SERVICE BULLETIN

SERVICE BULLETIN		No.: MSB-97E17-501	
		Date: 1997-07-15	<Model> (EC,EXP)GALANT <M/Y> 97-10 (EA0)
Subject: CORRECTION OF ERRORS IN REGARD TO ACCELERATOR PEDAL POSITION SENOR BRACKET			
Group: ENGINE & EMISSION CONTROL		Draftno: 97-JY-001	
CORRECTION	OVERSEAS SERVICE DEPT	<i>R. Usami</i> R. USAMI - MANAGER QUALITY INFORMATION ANALYSIS

ACCELERATOR PEDAL POSITION SENSOR REMOVAL AND INSTALLATION

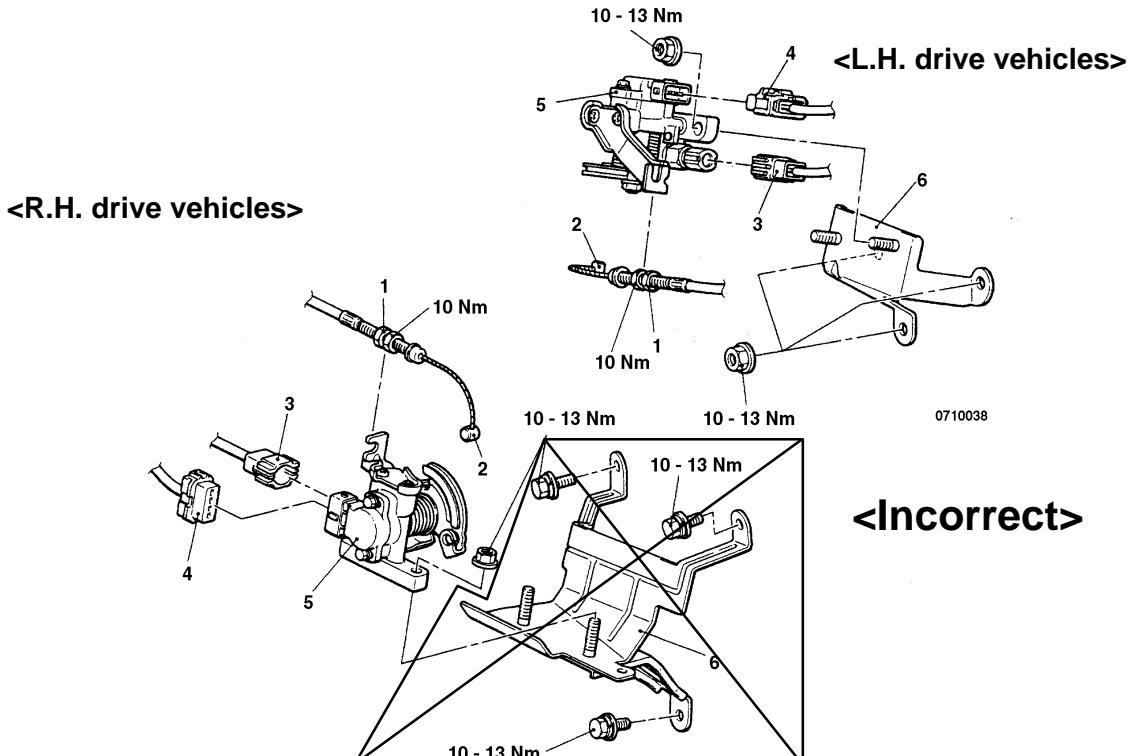
This Service Bulletin informs you that errors have been corrected in regard to the accelerator pedal position sensor bracket (on RH drive car).

<Correct>
